Access Compliance Report

Public Rights-of-Way

Intersection ID: 3740	Main Street: CHESTNUT_KNOLL_LN	Cross Street: DAVIS_LAKE_PY	Location:	W
ADA ID: 9049717EC057	Ramp Type: Perp	Initial Pass/Fail: Fail	Overall Compliance: No	Severity Score: 10
Codes/Mitigation Info/Possible Solution		Field Measurements/Component Compliance

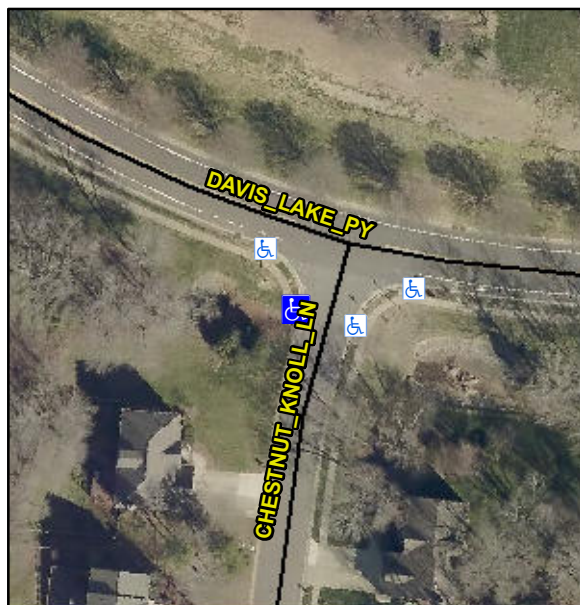
Not Found, R304.5.1, R304.5.3

Compliance	Description	Data	Compliance	Description	Data
N/A	Ramp Length (in)	53.0	Yes	Ramp Slope (%)	7.6
No	Ramp Width (in)	46.0	No	Ramp XSlope (%)	4.6
N/A	Flare Type LT	N/A	N/A	Flare Type RT	N/A
N/A	Flare Slope LT (%)	N/A	N/A	Flare Slope RT (%)	N/A
N/A	Flare Traversable LT?	N/A	N/A	Flare Traversable RT?	N/A
N/A	Landing Length (in)	N/A	N/A	DWS Provided?	N/A
N/A	Landing Width (in)	N/A	N/A	DWS Contrast?	N/A
N/A	Landing Slope (%)	N/A	N/A	DWS Length (in)	N/A
N/A	Landing X Slope (%)	N/A	N/A	DWS Full Width?	N/A
N/A	Landing Curb? (Y/N)	N/A	N/A	DWS Offset (in)	N/A
N/A	Shared Landing?	N/A			
N/A	Gutter Ponding?	N/A	N/A	Gutter Slope (%)	N/A
N/A	Gutter Lip Ht (in)	N/A	N/A	Gutter X Slope (%)	N/A
N/A	Painted X Walk1?	No	N/A	Painted X Walk2?	N/A
	X Walk 1 Direction	To SE		X Walk 2 Direction	N/A
N/A	X Walk 1 Width (in)	N/A	N/A	X Walk 2 Width (in)	N/A
	X Walk 1 Slope (%)	3.2		X Walk 2 Slope (%)	N/A
	X Walk 1 X Slope (%)	1.4		X Walk 2 X Slope (%)	N/A

Remove & Replace Entire Ramp.
